SERVICE BULLETIN

Classification: BT97-008a	Reference: NTB97-046a	Date: November 1, 1997
------------------------------	--------------------------	---------------------------

1995-97 MAXIMA POWER SEAT LIFT MOTOR OUTPUT GEAR STRIPPED

APPLIED VEHICLE: 1995 through early 1997 Maxima (A32)
APPLIED VIN(S): Vehicles built before JN1CA21D*VT807898,
JN1CA21D*VT202921 and JN1CA21D*VM501784
APPLIED DATE: Vehicles built before August 3, 1996

Figure 1

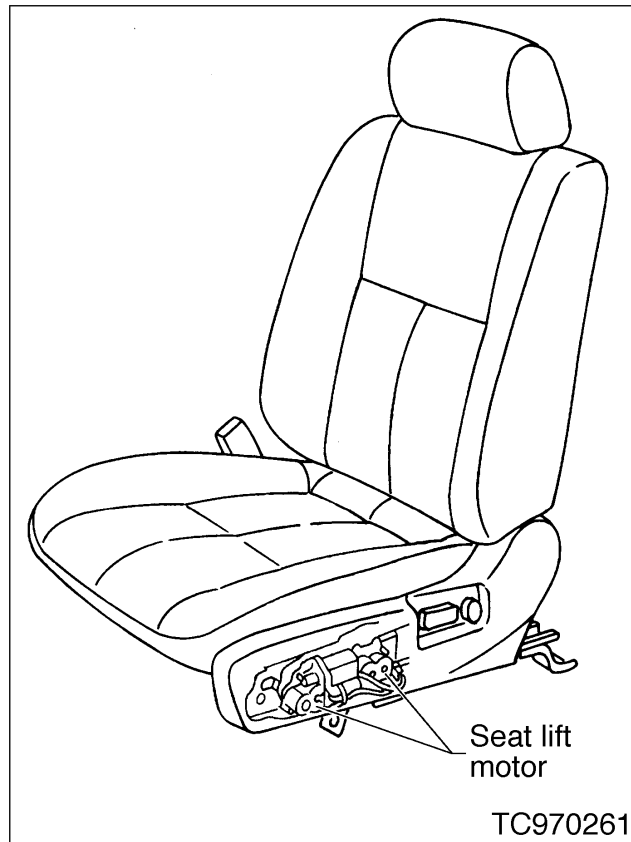
1. To verify this condition, operate the lift switch while sitting in the seat.
2. Listen for the motor operation and watch the seat for a change in height.
3. If there is no seat movement, remove the motor from the seat frame and inspect the plastic gear (see Figure 1, page 2).
4. If the plastic gear is stripped, use the procedures in the BT section of the service manual to replace the adjuster assembly and finisher assembly with the countermeasure parts.

A countermeasure adjuster assembly and finisher assembly are available to address this incident.

Individual countermeasure parts are not interchangeable - replace them as a set only.
